# **Partial Revisions of the Application Documents for Approval to Amend the Implementation Plan Regarding the Handling of ALPS Treated Water [Overview]**

April 24, 2023

Tokyo Electric Power Company Holdings, Inc.

# [Reference] Organization chart for the discharge of ALPS treated water into the sea

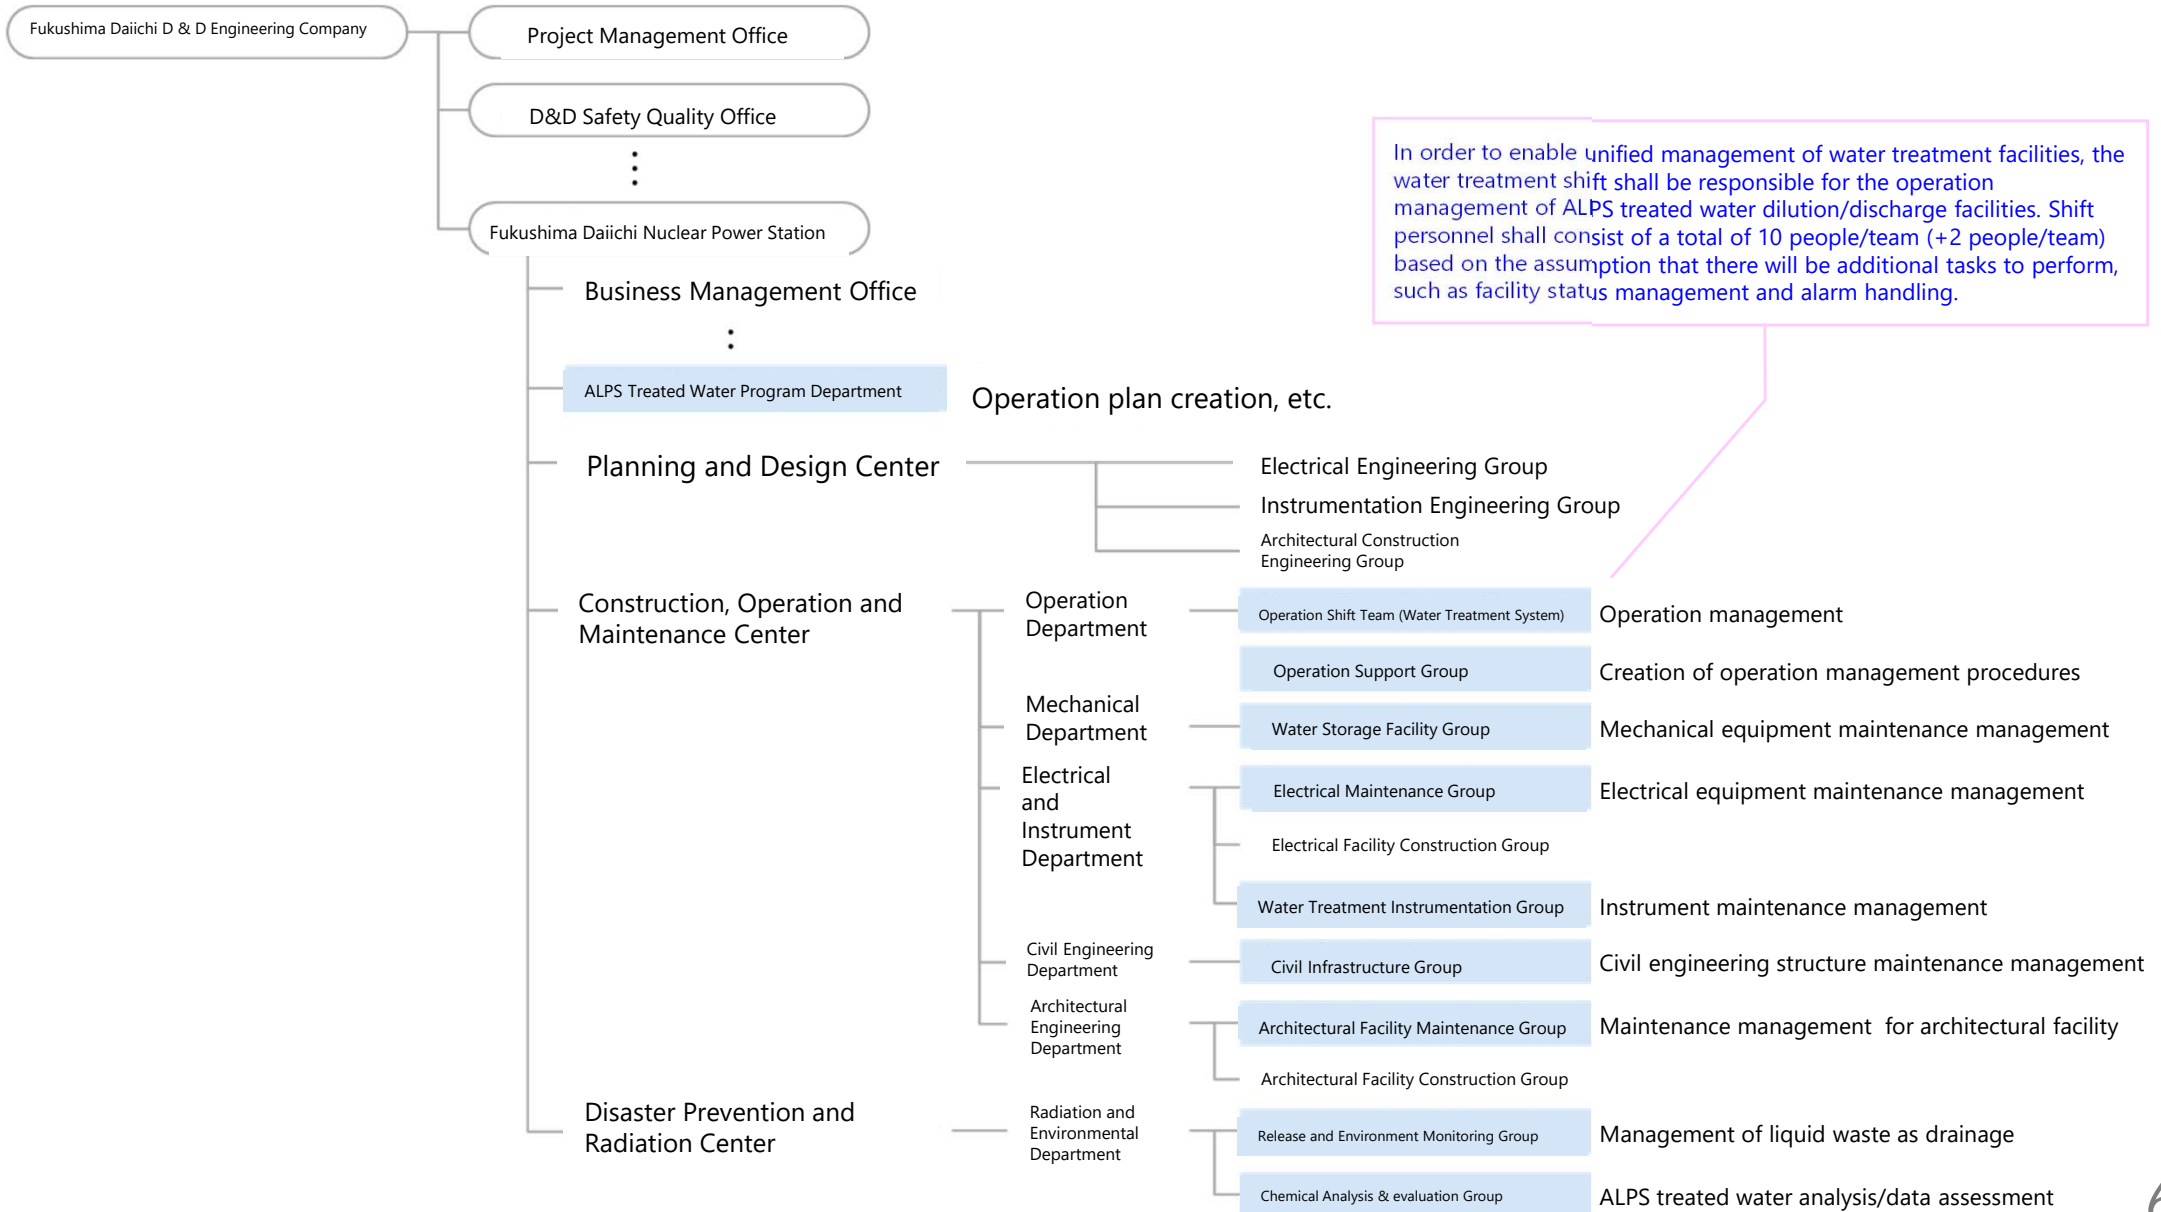
- The organizational chart of the FDEC below has been used to show the departments that will be managing the sea discharge of ALPS treated water
- It was confirmed at the Technical Meeting to Review the Implementation Plan for the Specified Nuclear Facility that facility maintenance and operation departments are covered.

In order to enable unified management of water treatment facilities, the water treatment shift shall be responsible for the operation management of ALPS treated water dilution/discharge facilities. Shift personnel shall consist of a total of 10 people/team (+2 people/team) based on the assumption that there will be additional tasks to perform, such as facility status management and alarm handling.

Primary changes to this revised application

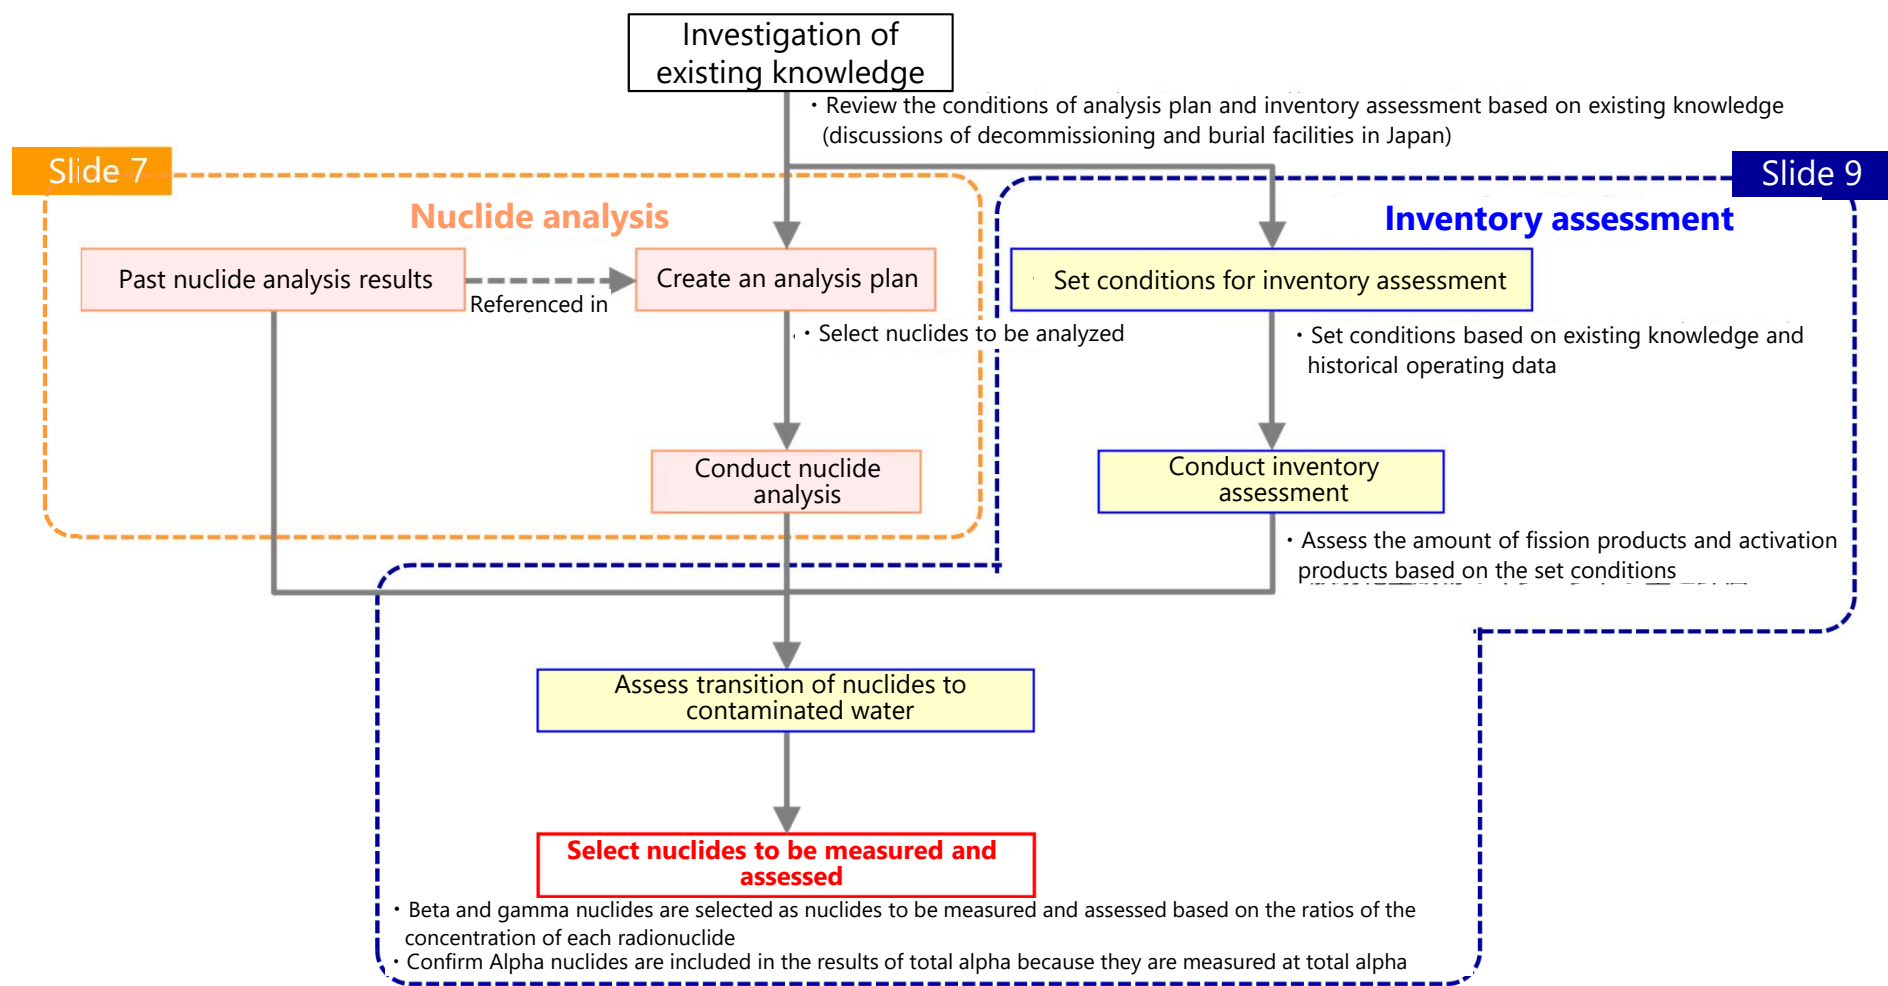
Based on discussions at the Technical Meeting, etc., we have partially revised procedures for selecting nuclides targeted for measurement/assessment through an inventory assessment, and have reselected the nuclides targeted for measurement/assessment (29 nuclides) and the nuclides targeted for monitoring (six nuclides).

# 4-4. Selection of nuclides to be measured and assessed through inventory assessment

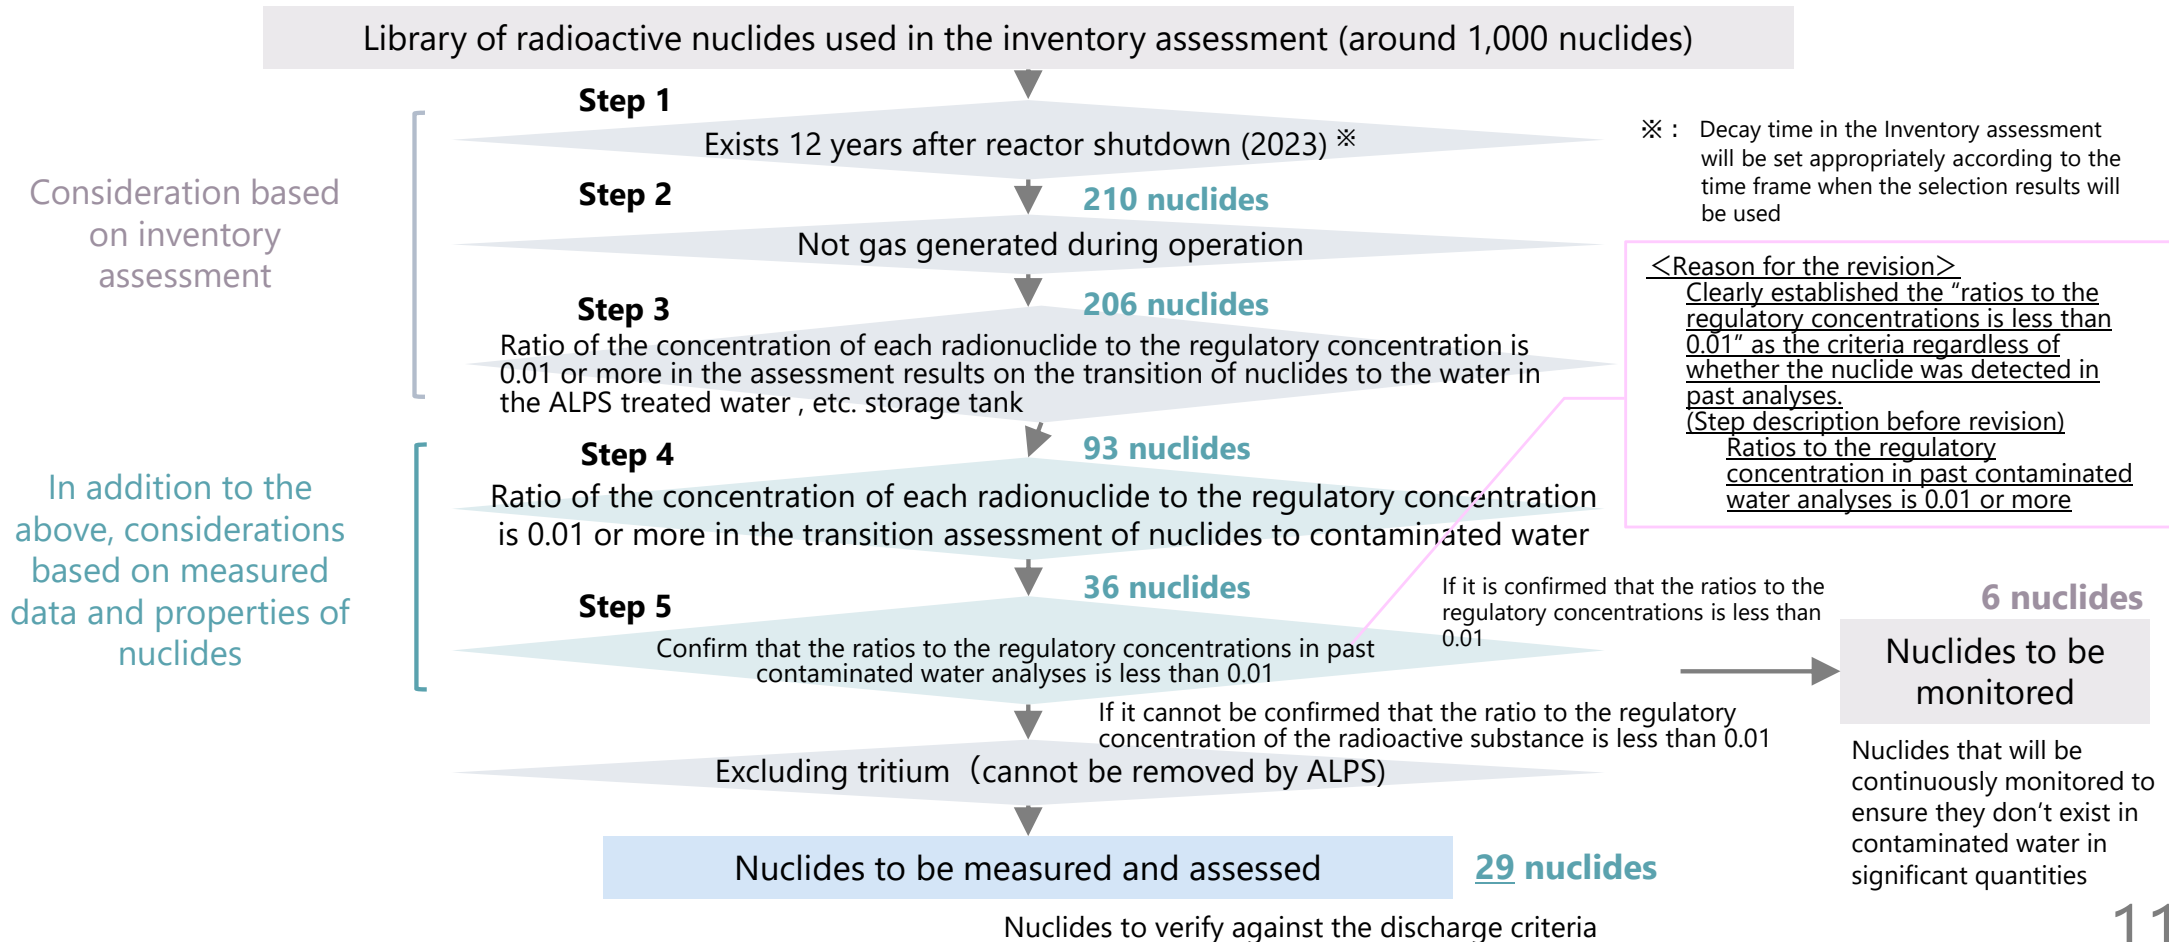
- The nuclides to be measured and assessed were selected using the following process.
- Regarding the following process, first, the nuclides that can realistically exist are selected considering the half-life of the nuclides based on the findings pointed by the IAEA and the NRA. Next, we conduct another desk study assuming\* that all of the radioactive materials have been transferred to the ALPS treated water storage tanks. Then nuclides that could exist in significant concentrations in contaminated water are evaluated based on the actual measured data of contaminated water and the properties of nuclides that we have accumulated over the past 12 years.
- In the revised application, Step 5 was partially revised based on discussions in the Technical Meeting to Review the Implementation Plan for the Specified Nuclear Facility, etc.

## 5-2. Approach to any abnormalities found during sea area monitoring after the commencement of discharge ②

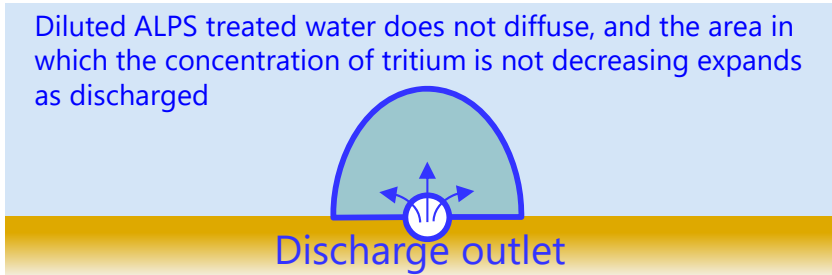
Underlined parts: Major areas of updated (Change made in partial revision on February 20)

- The following approach to handling abnormalities has been added to determine if sea discharge should be suspended when abnormalities are discovered during sea area monitoring.

Item	Details	
Situation determined as abnormal	<ul style="list-style-type: none"> <li>After the ALPS treated water has been diluted with a large volume of seawater and discharged from the outlet, if the discharge water does not diffuse into the seawater and the concentrations of tritium do not decrease, and the scope of the area in which these conditions persist enlarges</li> </ul> <div data-bbox="824 539 1653 815" style="text-align: center;"> <p style="color: blue;">Diluted ALPS treated water does not diffuse, and the area in which the concentration of tritium is not decreasing expands as discharged</p>  <p style="color: blue;">Discharge outlet</p> </div> <p style="text-align: center;">Concept diagram of area around discharge outlet</p>	
Target location	In the vicinity of the discharge outlet	In the vicinity of the power station (outside of the area mentioned to the left)
If applicable	<ul style="list-style-type: none"> <li>If monitoring value exceeds discharge limit, which had been set to ensure that the concentrations of tritium do not exceed the upper limits stipulated by government policy (1,500Bq/L) even in consideration of uncertainty in facility or measurements.</li> </ul>	<ul style="list-style-type: none"> <li>If clearly abnormal values are obtained during the analysis of tritium concentrations in seawater performed in order to quickly ascertain conditions</li> </ul>

Procedures	<ul style="list-style-type: none"> <li>Based on this approach, procedures, such as detailed sampling locations and values used to determine abnormalities, etc., will be added to internal manuals</li> </ul> <p>Furthermore, in addition to that mentioned above, necessary steps be taken if it is confirmed/determined that monitoring conditions differ from the normal conditions in the entire monitoring laid out in the comprehensive monitoring plan</p>
